SERIAL: HNP-02-142

SHEARON HARRIS NUCLEAR POWER PLANT, UNIT NO. 1
DOCKET NO. 50-400/LICENSE NO. NPF-63

RESPONSE TO REQUEST FOR ADDITIONAL INFORMATION REGARDING GENERIC
LETTER 96-06, "ASSURANCE OF EQUIPMENT OPERABILITY AND CONTAINMENT
INTEGRITY DURING DESIGN-BASIS ACCIDENT CONDITIONS"

SIMPLIFIED DIAGRAM OF AFFECTED SYSTEMS

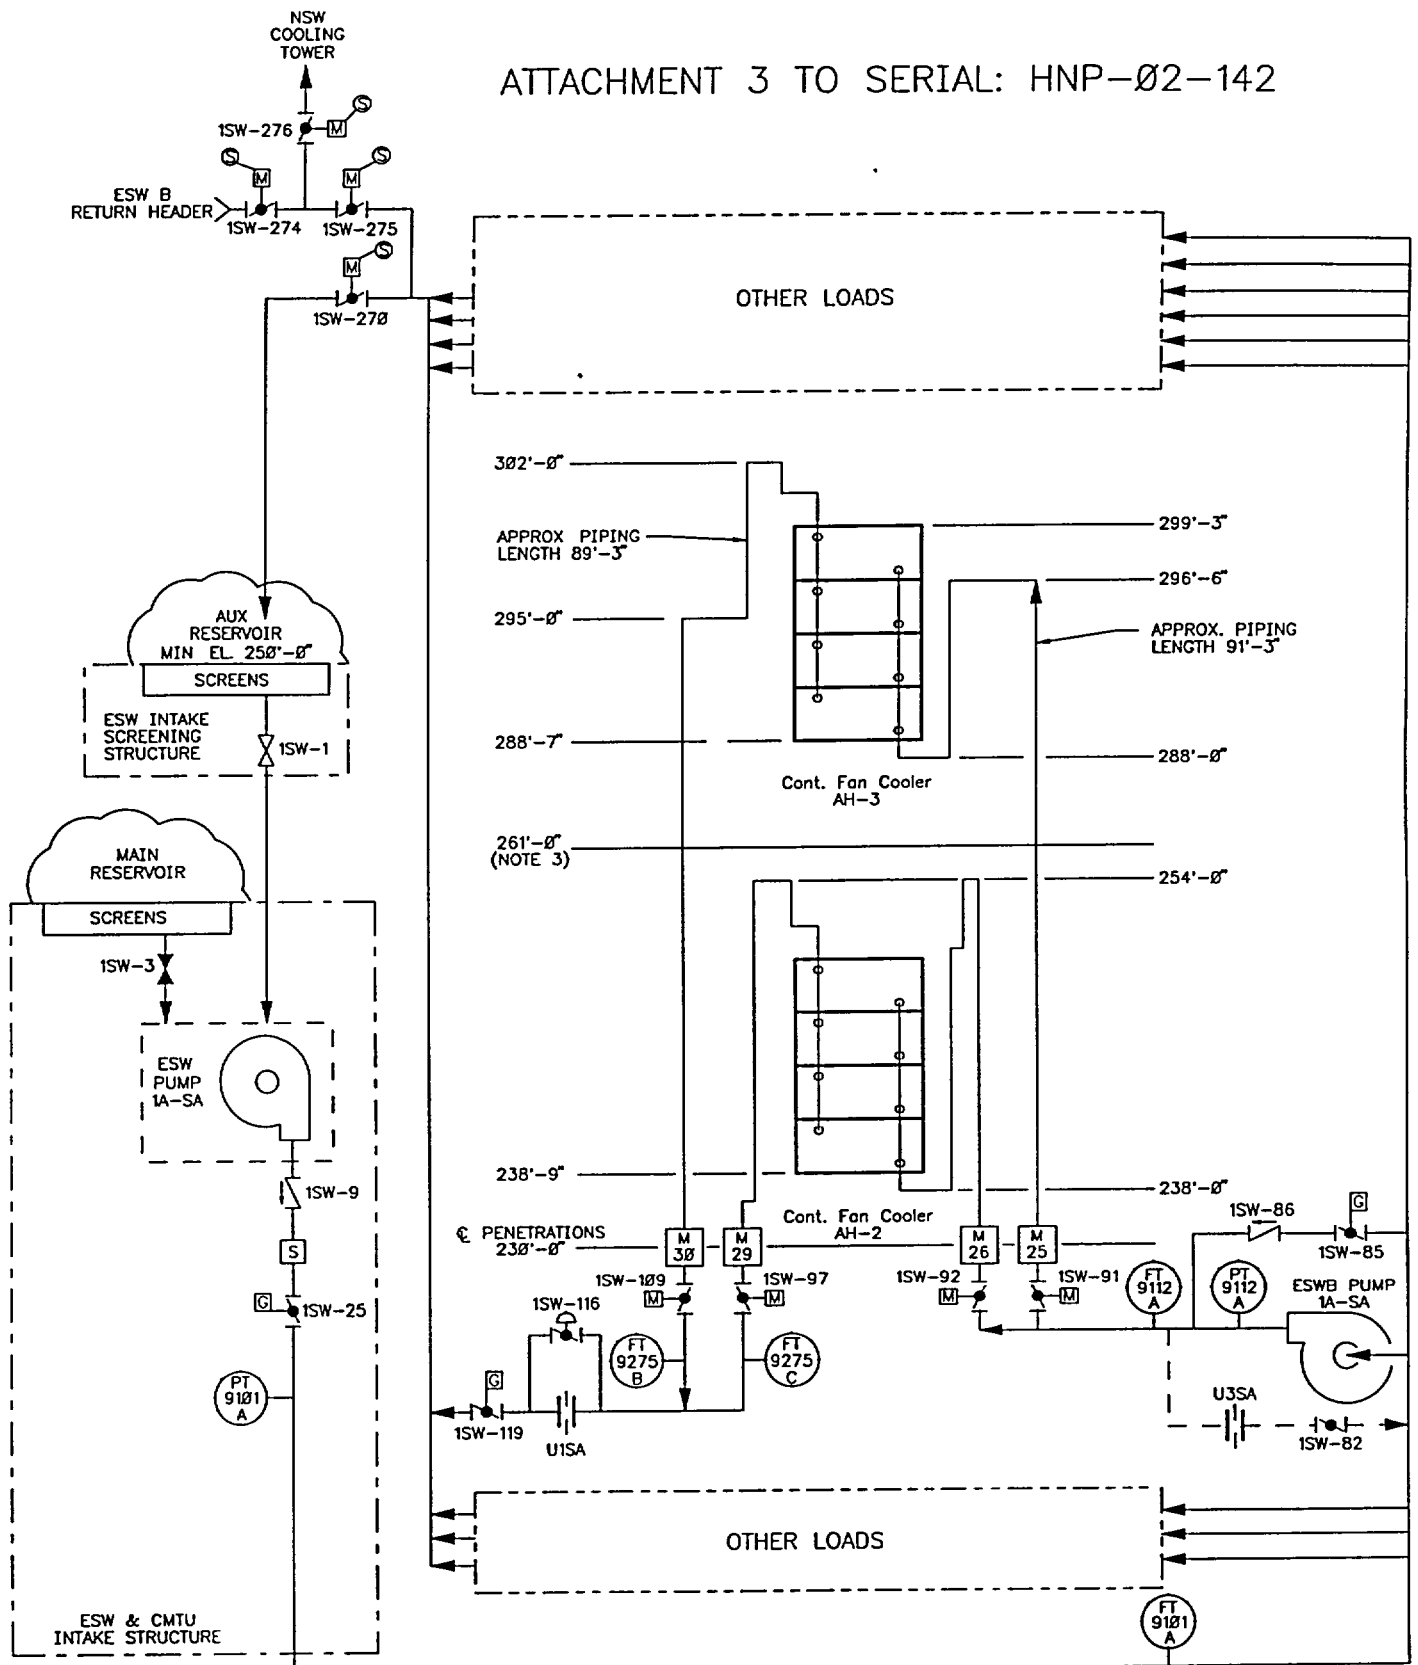
6. Provide a simplified diagram of the system, showing major components, active components, relative elevations, lengths of piping runs, and the location of any orifices and flow restrictions.

6. A simplified diagram of affected systems has been provided in Attachment 3.
7. Operating procedures have been modified to prevent the system from draining during a simulated Loss of Off-Site Power (LOOP) test. Normal Service Water is used to pressurize the system to ensure that voiding does not occur before the Emergency Service Water (ESW) pumps are started, and to ensure that waterhammers are prevented. No procedure change is required for the two-phase flow issue.

1. WITH THE EXCEPTION OF CFC PIPING INSIDE THE CONTAINMENT, THE COMPONENTS IN THE CFC FLOW PATH SHOWN ON THIS SIMPLIFIED DIAGRAM ARE BELOW GRADE ELEVATION (EL. 261'00")
2. "B" TRAIN OF ESW IS SIMILAR BUT NOT SHOWN FOR CLARITY
3. THE APPROXIMATE PIPING LENGTHS ARE SHOWN FOR THE CRITICAL RUNS INSIDE CONTAINMENT ABOVE EL. 261'00"
